Proposed Residential  
Development at Dyke Road,  
Co. Galway

Stage 1 Road Safety Audit

Document Ref:	P24-092-PMCE-XX-XX-RP-SA-3_0001
---------------	---------------------------------

### 3.1 Lack of Edge Protection

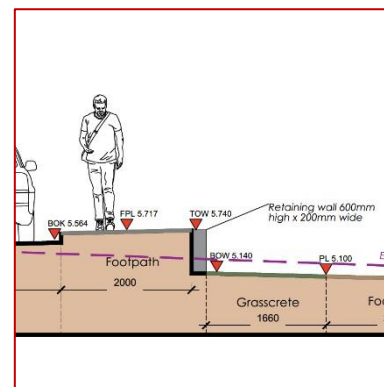
*Summary:* No edge protection has been indicated along the retaining wall where there is a drop in height to its rear.

A low retaining wall has been indicated to the rear of the footpath on the eastern side of Dyke Road for a short distance extending southwards from the proposed development's northern access. The top of the retaining wall is indicated as being level with the adjacent footpath, however a vertical drop of 600mm has been indicated between the footpath and the Grasscrete material within the development (see Section A-AA on Drawing No. 1911\_PL\_S\_01 (Rev. 0)), and no edge protection has been indicated at this location.

This may lead to pedestrians, particularly the visually-impaired, inadvertently straying from the footpath and falling to the rear of the wall resulting in a risk of personal injuries.

Edge protection should be provided along the top of the retaining wall at this location throughout the extent of the exposed level difference.

### 3.2 Visibility for Reversing Drivers

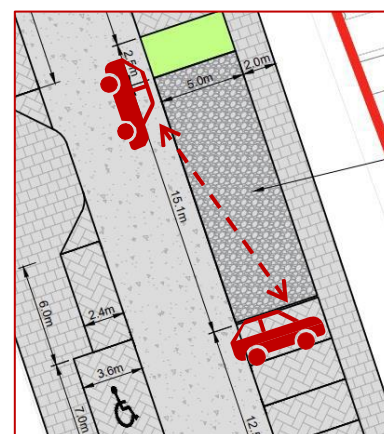
*Summary:* The proposed WWPS may be located such that it could obstruct the visibility of a driver exiting the adjacent parking space.

A WWPS has been indicated on the southern side of the development's southern access road, located within the row of perpendicular parking spaces on this side of the access road. The layout of the WWPS is unclear however it is assumed that a building, or fenced, area would be provided at this location.

The location of the WWPS may be such that it may obstruct visibility for a driver exiting the adjacent parking space, at its western boundary, particularly when reversing. This may lead to drivers entering the access road ahead of oncoming vehicles, resulting in potential low-speed side-on collisions.

An assessment should be undertaken to confirm that a driver exiting the adjacent parking space, particularly when reversing, would have sufficient visibility towards a driver approaching from the east.

Where sufficient visibility cannot be achieved measures should be provided, such as providing a grassed buffer area on the western side of the WWPS, similar to that provided on its eastern side, to maximise visibility.

### 3.3 Swept Path of Large Vehicles

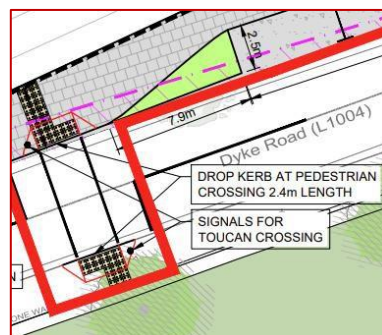
**Summary:** The swept paths of various large vehicles are indicated as colliding with a row of bollards at the turning circle.

The swept path of large vehicles, including a fire tender, medium refuse vehicle, large refuse vehicle and removal van, performing a U-turn manoeuvre at the turning circle at the eastern end of the proposed development's southern access road have been provided to the Audit Team. The swept paths of these vehicles undertaking this manoeuvre indicate that they would overrun the edge of the turning circle carriageway and collide with the row of bollards indicated on its southern side which may result in material damage collisions.

The row of bollards should be removed, and alternative measures provided to restrict unauthorised parking at this location.

### 3.4 Width of Toucan Crossing

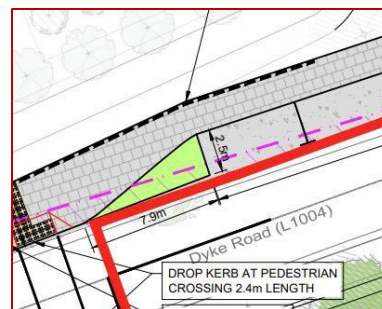
**Summary:** The width of the proposed Toucan crossing may be insufficient to cater for the volume of pedestrians and cyclists that may utilise it.

A new Toucan crossing has been indicated on Dyke Road immediately south of the proposed development's northern access. The crossing is indicated as being 2.4m wide which may not be sufficient to cater for the volume of pedestrians and cyclists that may utilise the crossing simultaneously. Should the crossing provided not be of a sufficient width to accommodate both pedestrians and cyclists, there is an increased risk of pedestrian-cyclist collisions when waiting at, and using, the crossing.

The width of the Toucan crossing should be a minimum of 4m in accordance with Section 4.3.2 of DMURS.

### 3.5 Lack of Taper at Parallel Parking Space

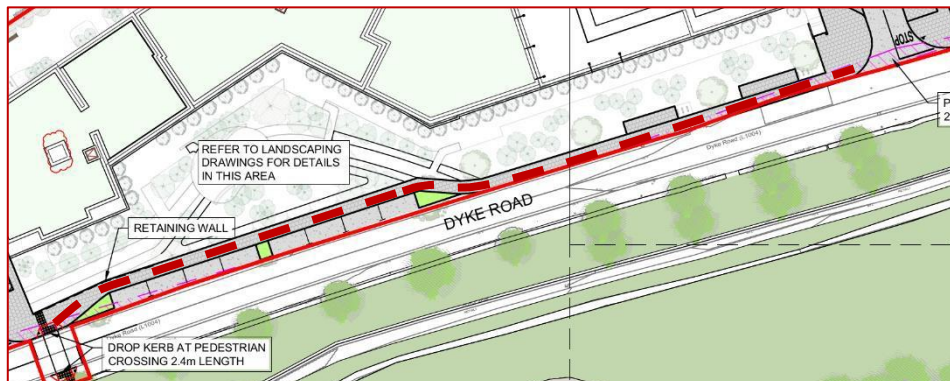
**Summary:** Drivers may experience difficulties entering/exiting the parallel parking spaces on Dyke Road due to the absence of a taper.

A row of parallel parking spaces has been indicated on the eastern side of Dyke Road. No taper in the adjacent kerb line has been indicated at the northern and southernmost parking spaces and this may lead to drivers experiencing difficulties entering these parking spaces, resulting in a risk of kerb strikes and material damage collisions.

The kerb line adjacent to these parking spaces should be amended to provide appropriate entry and exit tapers.

### 3.6 Width of Shared Path

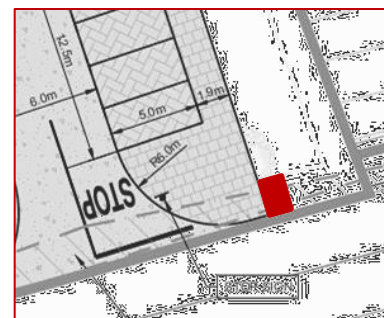
**Summary:** The proposed footpath may not be of a sufficient width to accommodate both pedestrians and cyclists.

There are a number of visitor/short-stay bicycle stands indicated within the footpath on the eastern side of Dyke Road adjacent to the southern access to the proposed development. It is, therefore, likely that the footpath between the proposed Toucan crossing, further north, and the proposed southern development access would be utilised by both pedestrians and cyclists traveling to/from these bicycle stands.

The footpath at this location, however, is indicated as 2m wide, which would not be wide enough to accommodate both pedestrians and cyclists. This may result in an increased risk of conflicts between pedestrians and cyclists within this section of footpath.

The footpath between the Toucan crossing and the proposed southern development access should be sufficiently widened to accommodate both pedestrians and cyclists.

In addition, hazard tactile paving should be provided across the width of the footpath where it would transition to a shared surface, used by cyclists also.

### 3.7 Absence of Hazard Warning Tactile Paving

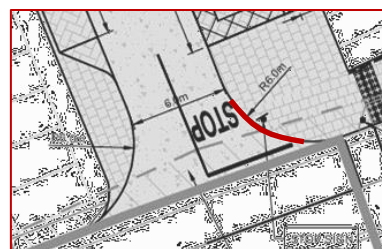
**Summary:** The absence of hazard warning tactile paving where the footpath would transition to a shared surface may lead to visually-impaired pedestrians being insufficiently aware that they are entering a space shared with both motorised vehicles and cyclists.

The access roads within the proposed development have been indicated as shared areas which would be shared by motorised vehicles, cyclists and pedestrians. No warning tactile paving, however, has been indicated where the existing footpath on the eastern side of Dyke Road, to the south of the development's southern access, would meet the shared surface. This may lead to visually-impaired pedestrians, approaching from the south, being insufficiently aware that they are entering an area shared with both motorised vehicles and cyclists where they would be at an increased risk of being struck by either of these road users.

Hazard warning tactile paving should be provided across the width of the footpath where the shared surface transitions to the footpath on the eastern side of Dyke Road.

### 3.8 Absence of Pedestrian Crossings

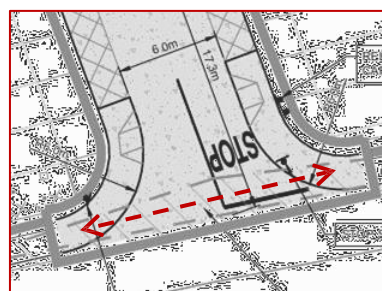
**Summary:** The absence of pedestrian crossings across the proposed development's accesses may result in visually and mobility-impaired pedestrians experiencing difficulties.

A footpath has been indicated on Dyke Road along the western boundary of the proposed development. This would create a desire line along the eastern side of Dyke Road extending southwards from the development's northern access. A pedestrian crossing of either of the development's accesses, including dropped kerbs and tactile paving, has, however, not been indicated.

This may lead to difficulties for the visually and mobility-impaired, particularly wheelchair users, in independently navigating the access when travelling northbound or southbound on the footpath, as they would be required to ascend/descend full height kerbs when crossing the accesses.

A pedestrian crossing, including dropped kerbs and tactile paving, should be provided across the northern and southern accesses to the proposed development.

### 3.10 Lack of Definition of Safe Zone

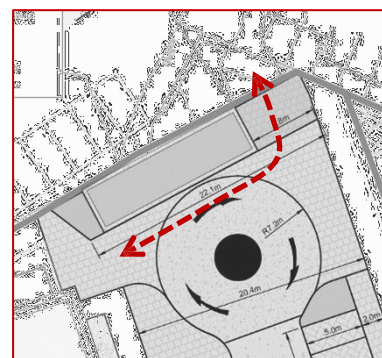
**Summary:** *The absence of a sufficiently defined safe zone within the shared areas at the proposed development's northern and southern accesses may result in visually-impaired pedestrians inadvertently entering the area shared with motorised vehicles.*

Section 2.3.2 of the Mobility Management Plan states that, "access to the development is a shared surface for vehicles, cyclists and pedestrians via the two new proposed access points of the development." It is, therefore, assumed that the carriageway and adjacent footpaths within the shared surface at the development's access roads are at the same level.

It is unclear, however, if there will be adequate tonal/material contrast between the footpath area and the carriageway area. The absence of vertical segregation and/or tonal contrast could lead to visually impaired pedestrians being unable to differentiate between the footpath and the carriageway within the shared surface, which could lead to them unknowingly entering the area shared with motorised vehicles where they are at risk of being struck by a vehicle.

Measures, such as providing a strip of warning tactile paving or utilising materials with sufficient textural/tonal contrast, should be provided at the transition between the footpath and carriageway areas within the shared surfaces to advise visually-impaired pedestrians of the different surfaces within the development and to guide them through it.

### 3.12 Absence of Hazard Warning Tactile Paving

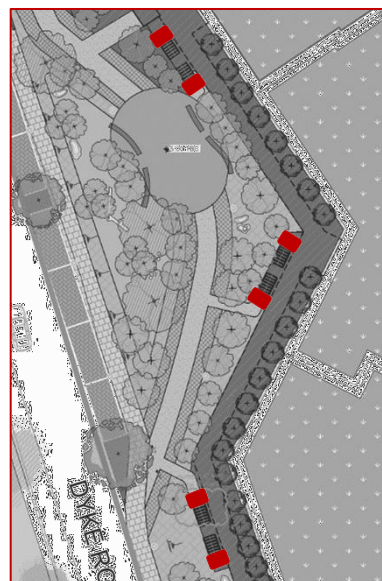
**Summary:** *The absence of hazard warning tactile paving at the top and bottom of steps within the proposed development may result in personal injuries.*

A number of steps have been indicated within the proposed development. However, hazard warning tactile paving has not been indicated at the top and bottom of the steps adjacent to the Building Core Entrances within the development. This could lead to visually-impaired pedestrians being insufficiently aware of the vertical hazard when approaching the steps, resulting in possible trips and falls.

Hazard warning tactile paving (corduroy) of a sufficient depth should be provided at the top and bottom of all steps within the proposed development.

### 3.13 Location of Cargo Bicycle Parking Stand

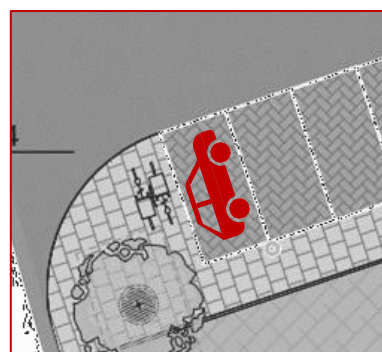
**Summary:** *There is a risk of material damage collisions where a cargo bicycle parking stand has been located in close proximity to an adjacent car parking space.*

A cargo bicycle parking stand has been indicated on the southern side of the proposed development's southern access road. The stand appears to be located in close proximity to the adjacent parking space such that vehicle occupants may experience difficulties entering/exiting a vehicle parked at this location, resulting in a risk of material damage collisions.

The cargo bicycle parking stand should be relocated such that there is a sufficient buffer area between the stand and the adjacent parking space.

### 3.15 Location of Public Lighting Columns

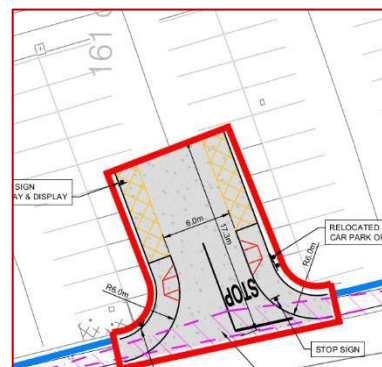
**Summary:** *It is unclear if public lighting columns would be sufficiently setback from the edge of the carriageway on Dyke Road and from the rear of parking spaces within the proposed development.*

Public lighting columns have been indicated throughout the proposed development, including along the eastern side of Dyke Road and to the rear of parking spaces at the development's two accesses. Should lighting columns be positioned such that they would be insufficiently setback from the edge of the carriageway and parking spaces, this may lead to an increased risk of drivers striking lighting columns, particularly when entering parking spaces, resulting in material damage.

All public lighting columns should be positioned a minimum of 450mm from the edge of the carriageway and to the rear of the parking spaces throughout the proposed development.
